Sequoyah Fuels Corporation

Second Request for Additional Information

Ground Water Monitoring Plan

Subject: Sequoyah Fuels Corporation, Docket – 40-8027
Response to Second Request For Additional Information – Ground
Water Monitoring Plan (TAC L52529)

Figure 1 – As Analyses at Port Road Bridge Seep (2245)

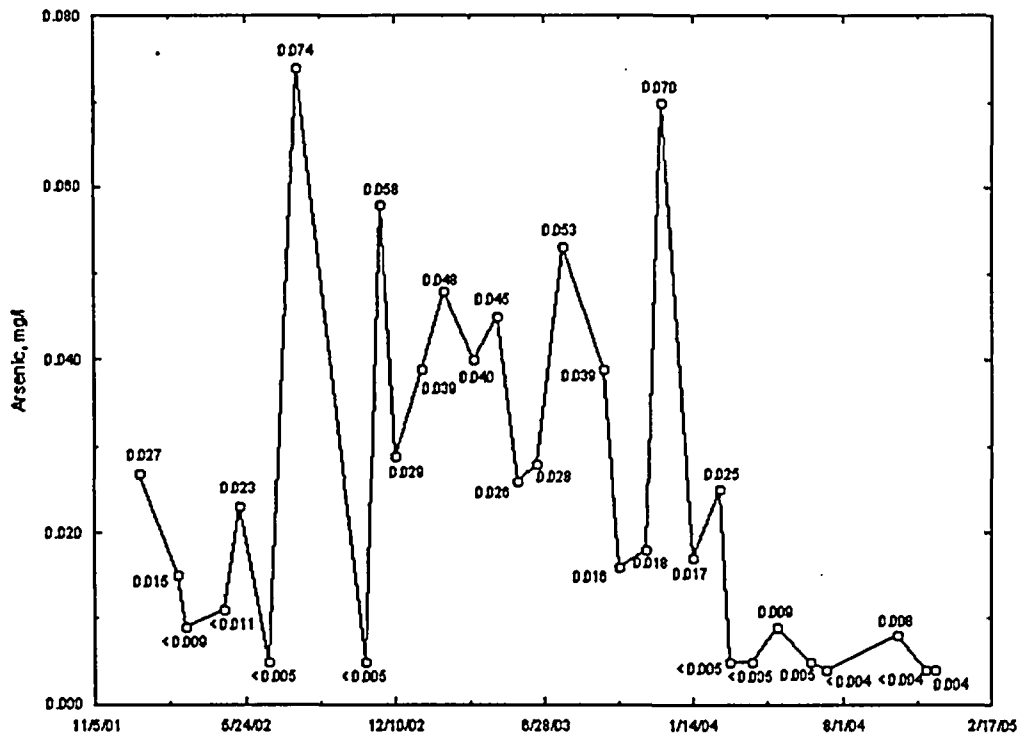
6. As stated in item 1 of our October 31, 2003 Request for Additional Information, groundwater contamination as a result of facility operations has not been fully characterized. SFC has satisfied some of the original concerns, however, the following concerns have not been addressed:
- a. arsenic down-gradient of MW095A in the shallow bedrock has not been adequately delineated, and
 - b. further delineation is needed down gradient of MW50A in Shale 2.

As seen from the data, arsenic concentrations decrease from the source (Pond 2) to the exposure point (2245) as the contaminated water moves toward the 001 Drainage. A downward trend has been observed since January 2003 in the arsenic concentrations at sample location 2245. This downward trend is attributed to the groundwater recovery system installed in this area. Figure 1 shows that the concentrations have decreased from greater than the MCL (0.05 mg/l) to less than 0.01 mg/l at 2245.

Adequate monitoring locations are available to track the progression of the arsenic plume to the west of Pond 2 without installing any new wells. STA04 has been added to the GWMP to provide adequate monitoring down gradient of MW095A in the next lower groundwater unit.
